World Forum for Harmonization of Vehicle Regulations

Proposal for Corrigendum 2 to Revision 2 of Regulation No. 87 (Daytime running lamps)

Note by the secretariat*

Figure 1"

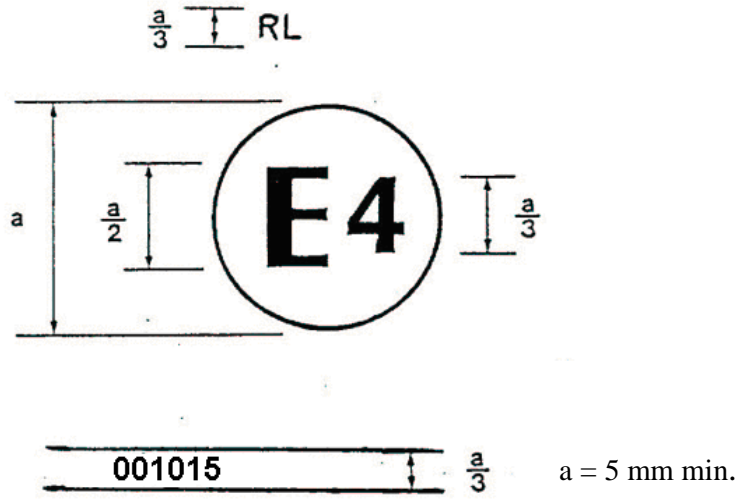
The text reproduced below was prepared by the secretariat to correct figure 1 of Annex 2 to Regulation No. 87. It is submitted to the World Forum for Harmonization of Vehicle Regulations (WP.29) and to the Administrative Committee (AC.1) for consideration.

Figure 1, amend to read:
